WHITMAN, REQUARDT & ASSOCIATES ENGINEERS 1304 ST. PAUL ST. BALTIMORE, MARYLAND	DEPARTMENT OF PUBLIC WORKS HOWARD COUNTY, MARYLAND DATE _____ CHIEF-BUREAU OF ENVIRONMENTAL SERVICES	CONTRACT NO. <u>500-S</u>	PROPOSAL NO.14 SECONDARY CLARIFIER NO.3 PART PLAN, PROFILES, & DETAILS	SAVAGE WASTEWATER TREATMENT PLANT ADDITION NO. 4	DRAWING NO. <u>1</u>	SCALE AS SHOWN
					OF <u>2</u>

△ SUPPLEMENTAL DRAWING - NO.133-A
 MODIFIED DRAWING - MAY 6, 1982

WHITMAN, REQUARDT & ASSOCIATES ENGINEERS 1304 ST. PAUL ST. BALTIMORE, MARYLAND	DEPARTMENT OF PUBLIC WORKS HOWARD COUNTY, MARYLAND DATE _____ CHIEF - BUREAU OF ENVIRONMENTAL SERVICES	CONTRACT NO. 500-S	PROPOSAL NO. 14 AERATION BASIN PIPE GALLERY PART PLANS	SAVAGE WASTEWATER TREATMENT PLANT ADDITION NO. 4	DRAWING NO. 2 OF 2 SCALE AS SHOWN
---	--	--------------------	--	---	--------------------------------------

△ SUPPLEMENTAL DRAWING - NO. 133-B
 MODIFIED DRAWING - MAY 6, 1982

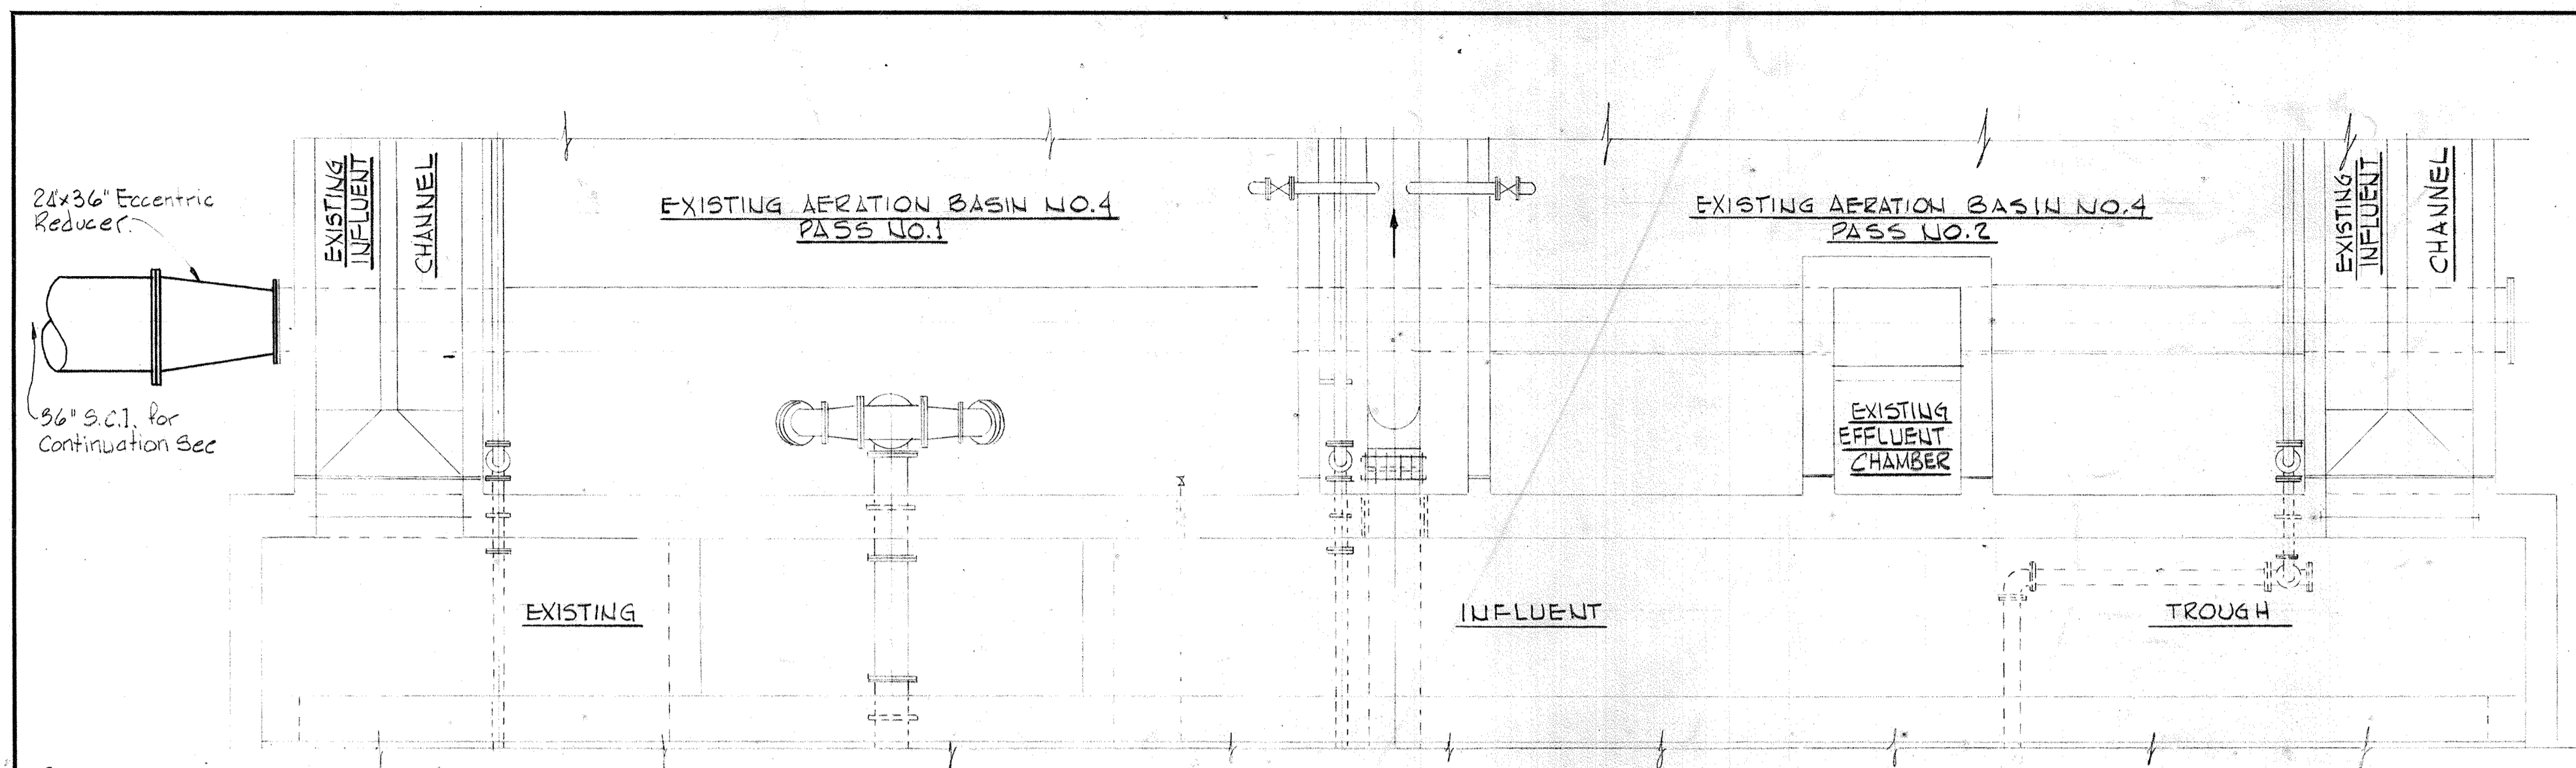
- NOTES:**
- Provide and install temporary "Y" Branch. Store 45° Bend & 36" Short piece 13'-3/2" (See C.P.P. Co. Inc. Lay Schedule.) Exact station to be determined by C.O. Lay Schedule for temporary connection.
 - When Design construction is to be completed (See Critical Path Schedule):
 (2A) drain clarifier, remove wye branch, Cap end of 36" 60° Bend, and complete installation of 36" S.C. Profile B-1 per contract drawing add C.P.P. Co. Inc. Lay Schedule
 - When Aeration Basin No.4 is removed from service for modifications, Remove all 36" steel pipe and fittings not embedded, plug end of 36" steel pipe header at Aeration Basin wall, and Complete concrete construction of Effluent Chamber.
- Wye Branch changed to 30° Bends 8-29-78
